### 3.9 Te Rapa North Industrial

The Te Rapa North Industrial Structure Plan applies to 91ha of the zone. The Structure Plan will further guide the development of the area to coordinate infrastructure upgrades and achieve good urban design outcomes.

**Figure 3.9.2.5.e:** Indicative Old Ruffell Road upgrade cross section [\(Collector\)](#)

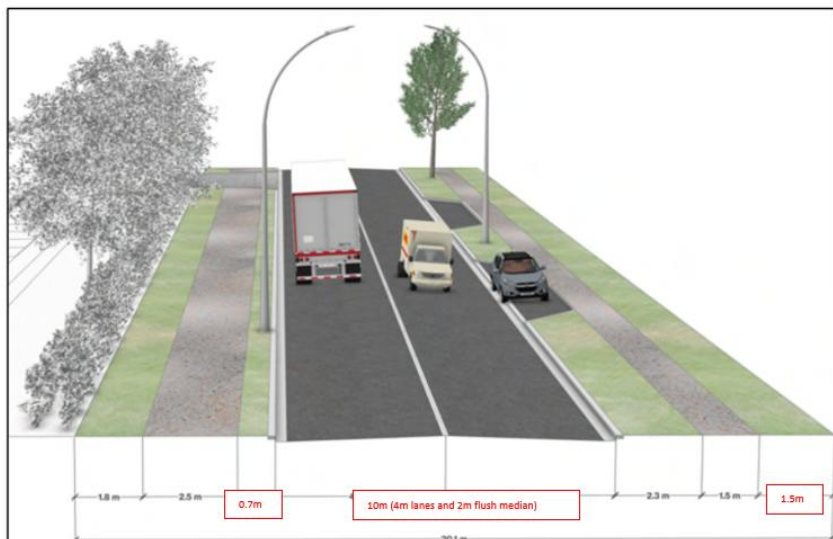
**Commented [HCC1]:** Image is updated to a cross section that includes a 10m carriageway width (4m lanes and 2m flush median ), will reduce berms as indicated on the inserted image.
